Item Name: Baggage Compartment Protector - Floor And Wall

DART SERVICE INSTRUCTION

TO AMEND INSTALLATION INSTRUCTIONS IIN-D407-781-2 REV. A OR LATER APPROVED REVISION
AND INSTRUCTIONS FOR CONTINUED AIRWORTHINESS ICA-D407-781 REV. 3 OR LATER REVISION

A	NEW ISSUE		13.04.08
REV.	DESCRIPTION	BY	DATE
DESIGN			
DRAWN			
CHECKED			
MFG. APPR.	N/A		
APPROVED			
DE APPR.			
DATE	13.04.08		
DART AEROSPACE LTD HAWKESBURY, ONTARIO, CANADA		REV. A SHEET 1 OF 2	
DRAWING NO. DSI 9649		SCALE NTS	
TITLE ALTERNATE INSTALL			
COPYRIGHT © 2013 BY DART AEROSPACE LTD. THIS DOCUMENT IS PRIVATE AND CONFIDENTIAL AND IS SUPPLIED ON THE EXPRESS CONDITION THAT IT IS NOT TO BE USED FOR ANY PURPOSE OR COPIED OR COMMUNICATED TO ANY OTHER PERSON WITHOUT WRITTEN PERMISSION FROM DART AEROSPACE LTD.

**FIGURE 1 - D3879-1 BAGGAGE COMPARTMENT WALL
PROTECTOR - ALTERNATE INSTALLATION**

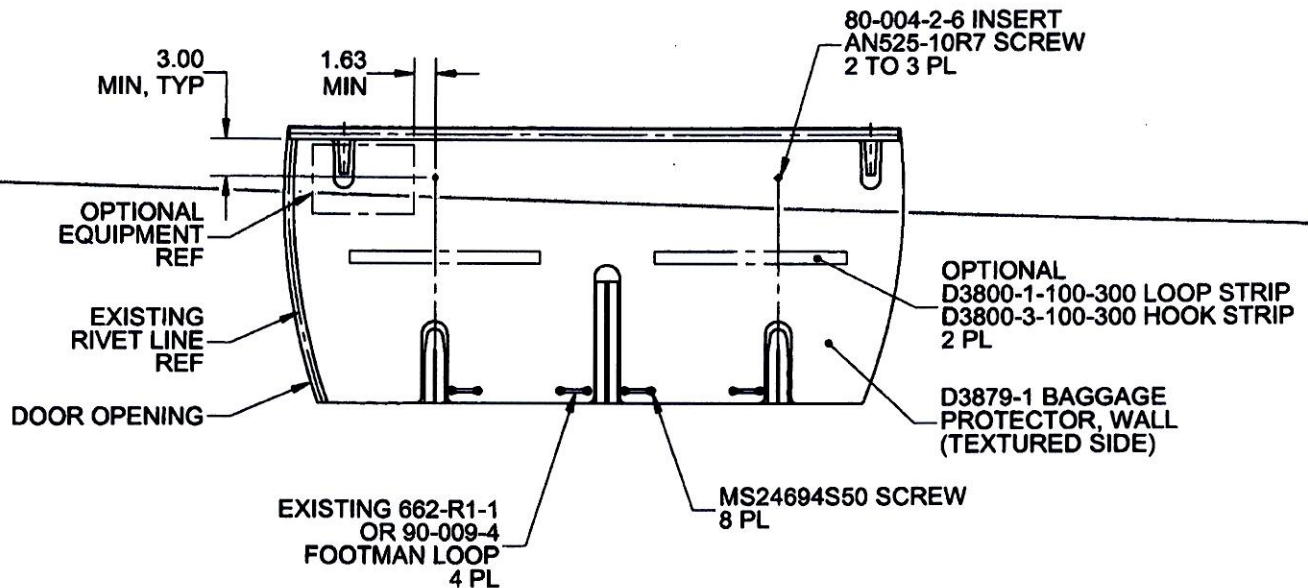
In some aircraft, the top portion of the D206-781-041 Baggage Compartment Wall Protector Kit cannot be installed as indicated in IIN-D407-781-2. The purpose of this DSI is to provide an alternate mounting method to fasten the top portion of the D206-781-041 Baggage Compartment Wall Protector Kit.

It is acceptable to replace qty(2) D3930-1 Clips with qty(2) 80-004-2-6 Inserts. Locate and mark location of the two attachment holes on the baggage compartment wall as shown in Figure 1 of this service instruction. Install 80-004-2-6 Inserts at the marked locations in accordance with Section 3-2-12 of BHT-206-SRM-1. It is acceptable to trim the wall protectors to accommodate optional equipment or transfer attachment holes to the wall protector and install the optional equipment on top of the wall protector with longer fasteners.

Amend the D206-781-041 Baggage Compartment Wall Protector Kit parts list as follows:

Qty -061	Qty -031	Qty -041	Part Number	Description
X			D206-781-061	BAGGAGE COMPARTMENT PROTECTOR KIT (FLOOR AND WALL)
1	X		D206-781-031	BAGGAGE COMPARTMENT FLOOR PROTECTOR KIT
1		X	D206-781-041	BAGGAGE COMPARTMENT WALL PROTECTOR KIT
		2	AN525-10R7	SCREW
		2	80-004-2-6	INSERT
